Drainage Strategy for Planning

Project Name: Grimshaw Lane, Manchester
Planning Number: 129444/FO/2021
PTA Project Number: 9762
Document Reference: 9762-PTA-XX-XX-RP-C-9080
Prepared by: LB
Checked by: SLW

Revision: P01

DRAWING TITLE
Proposed Sitewide Drainage Layout

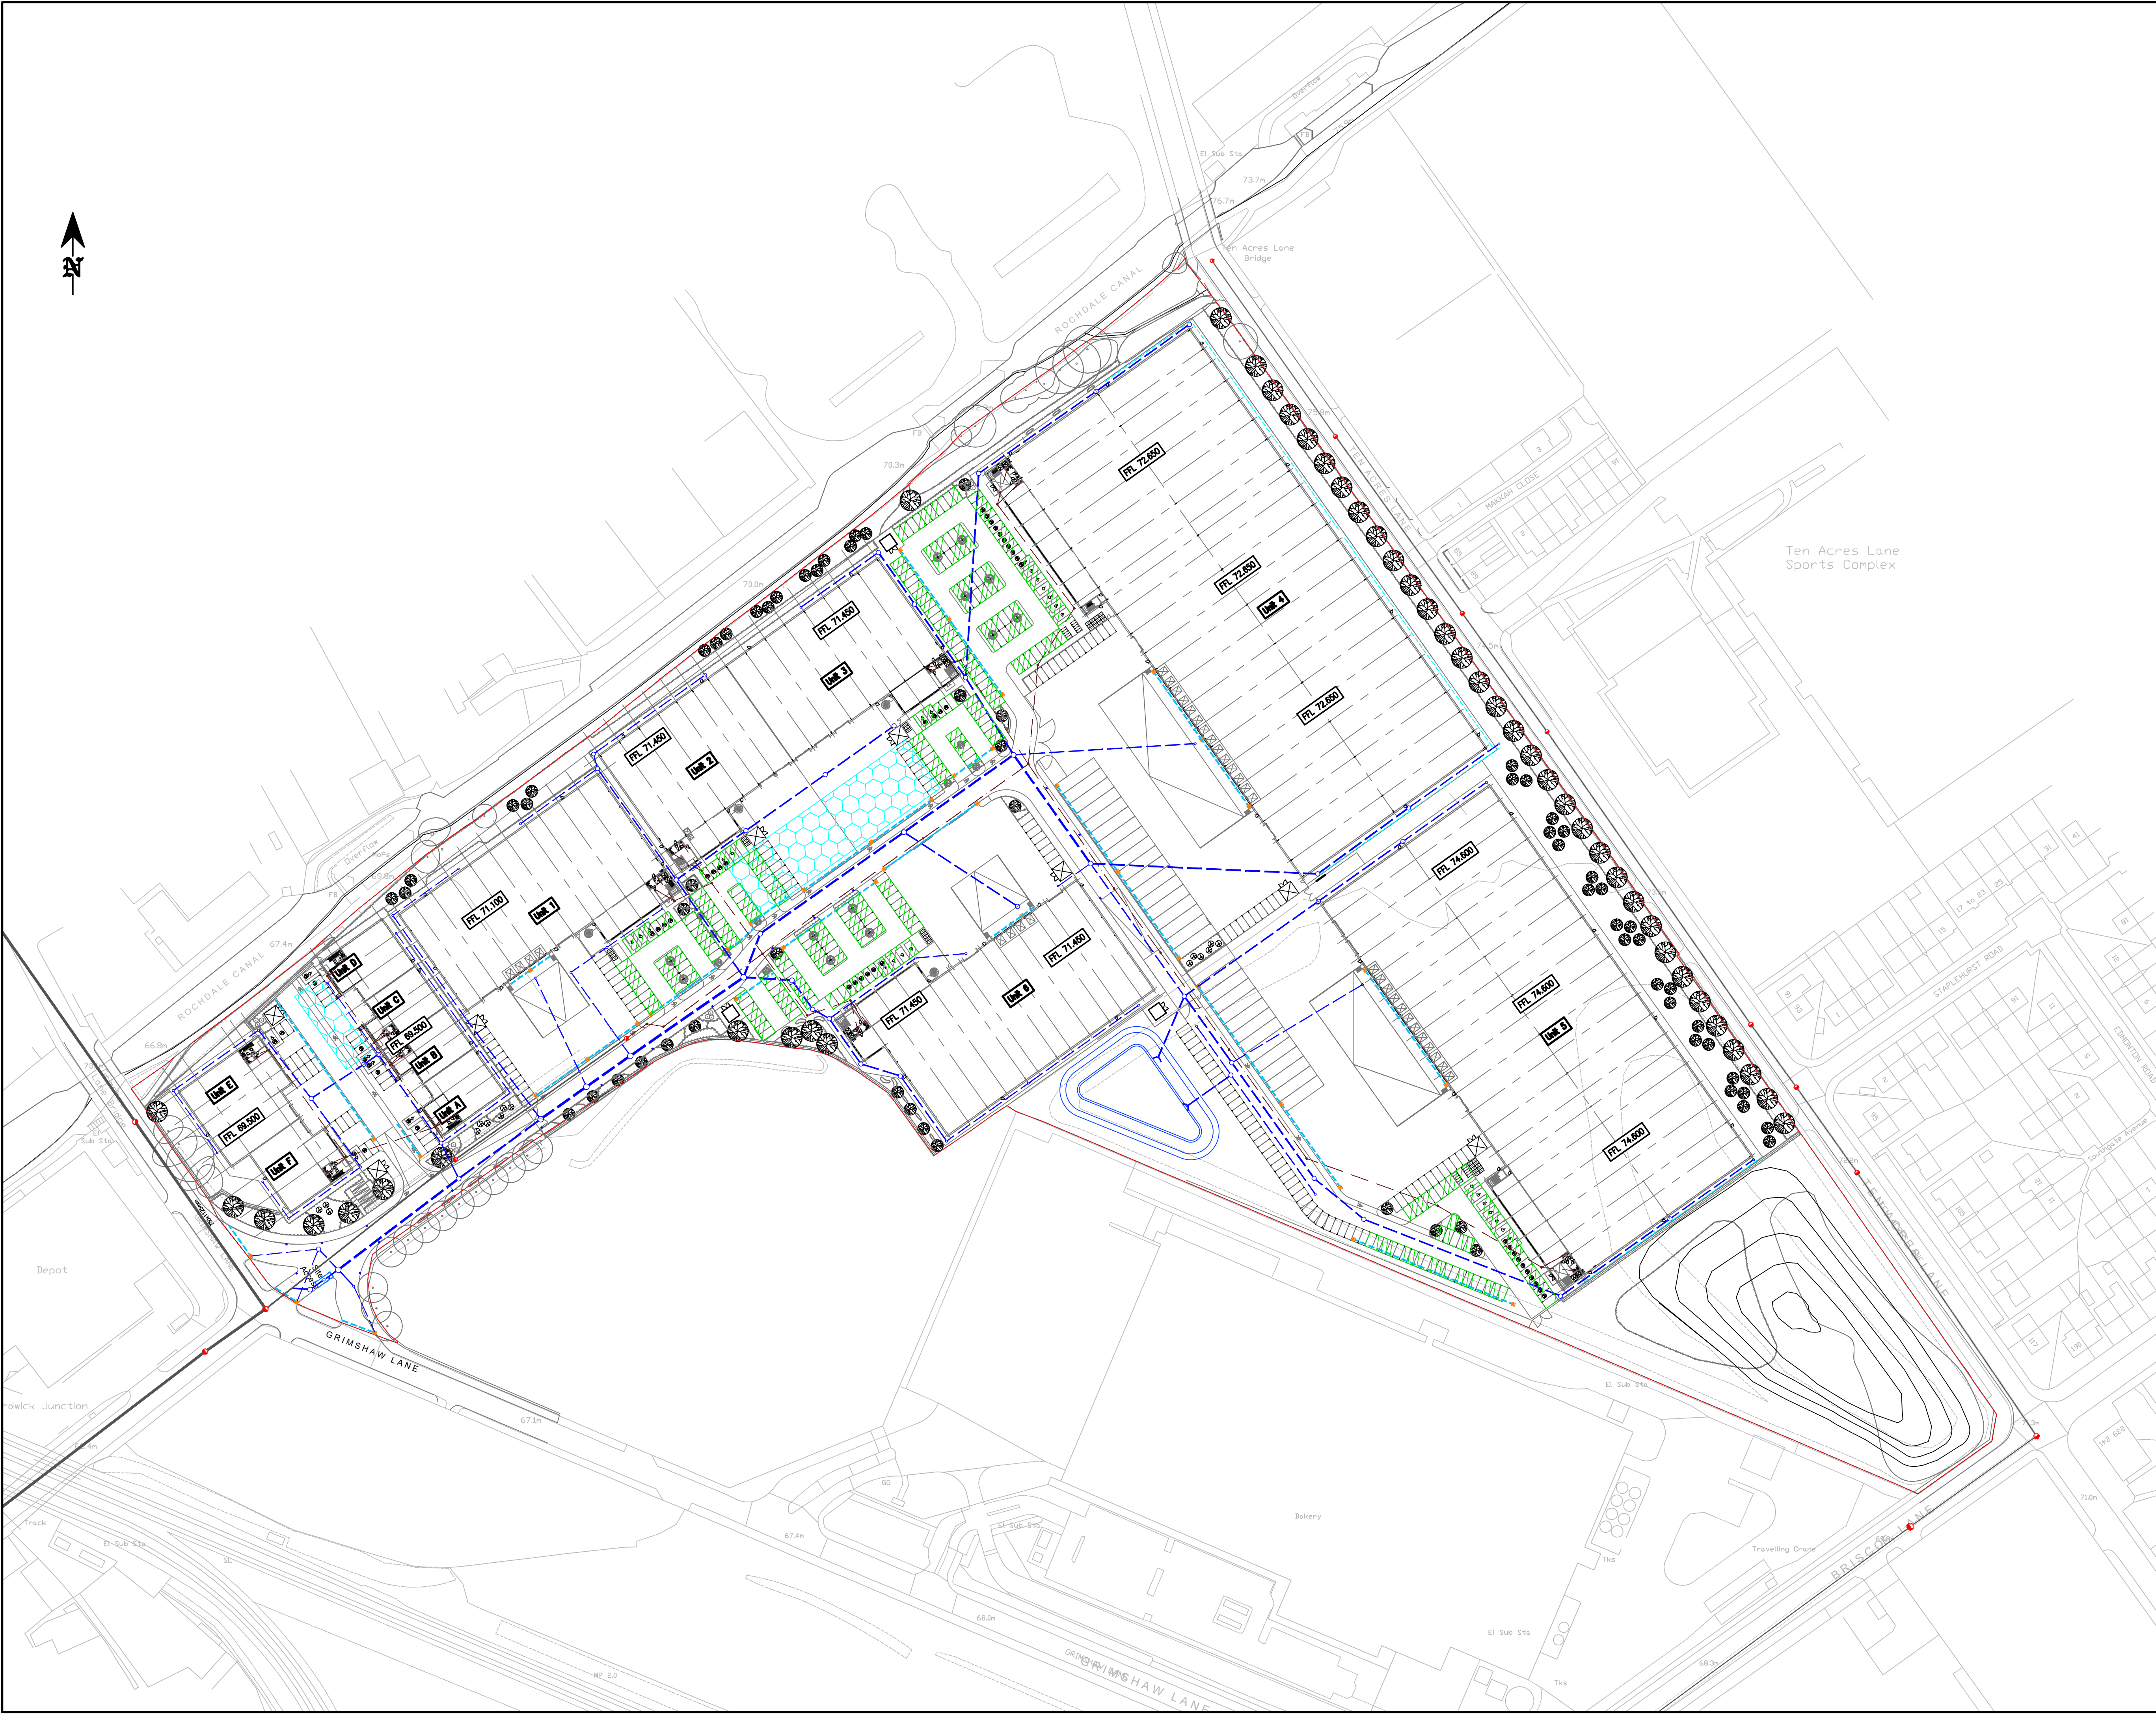
- The originally approved strategy had attenuation tank no.1 in units 2 & 3 yard with a storage volume of 2,250m³. This was sized to suit the whole site area but has now been split to provide a better representation between the phases. As such this tank has reduced in volume to 1,350m³ and a new tank has been provided in unit 4 yard of phase 2 with a storage volume of 900m³ (tank no.3). The overall attenuation storage volume remains the same, refer to enclosed calculations "9762 - SW Phase 1 & 2 - 95 l/s".
